Location of Construction: * 36 Coolidge Ave. 04103		Owner: George & Gloria Hammond		Phone: 797-2323		Permit No: 991104	
Owner Address: Same		Lessee/Buyer's Name: N/A		Phone:		Business Name:	
Contractor Name: Owner		Address: SAA		Phone:		Permit Issued: OCT 5 1999	
Past Use: 2-Family		Proposed Use: Same		COST OF WORK: \$ 1,500		PERMIT FEE: \$ 36.00	
				FIRE DEPT. <input type="checkbox"/> Approved <input type="checkbox"/> Denied		INSPECTION: Use Group: U Type: 5/1 Signature: [Signature]	
Proposed Project Description: Utilities needed for addition to existing garage. (Have Utilities Connected to addition to existing garage)				PEDESTRIAN ACTIVITIES DISTRICT (P.A.D.) Action: <input type="checkbox"/> Approved <input type="checkbox"/> Approved with Conditions <input type="checkbox"/> Denied		City of Portland Zone: CBL: 349-C-001 Zoning Approval: [Signature] Special Zone or Reviews: <input type="checkbox"/> Shoreland <input type="checkbox"/> Wetland <input type="checkbox"/> Flood Zone <input type="checkbox"/> Subdivision <input type="checkbox"/> Site Plan maj <input type="checkbox"/> minor <input type="checkbox"/> mm

BUILDING PERMIT REPORT

REASON FOR PERMIT: 12' x 12' addition to detach

Plot Plan

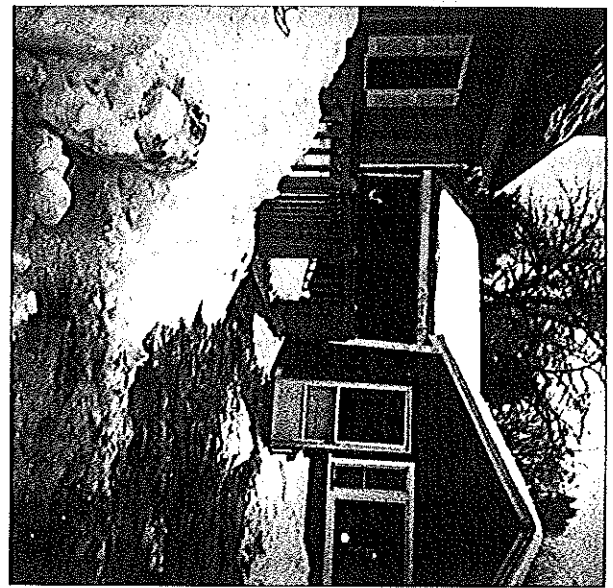
REASON FOR PERMIT: Addition onto a garage - NOT A NEW UNIT

8. Separate permits shall be required for any signage.
9. Separate permits shall be required for future decks, sheds, pool(s), and/or garage.
10. This is not an approval for an additional dwelling unit. You shall not add any additional kitchen equipment, such as stoves, microwaves, refrigerators, or kitchen sinks, etc. without special approvals. This shall be strictly enforced

Again, This is an accessory bedroom to your dwelling unit.
It is NOT A separate unit - It shall not be
rented out as such.
Marge Schmuckel
Marge Schmuckel, Zoning Administrator
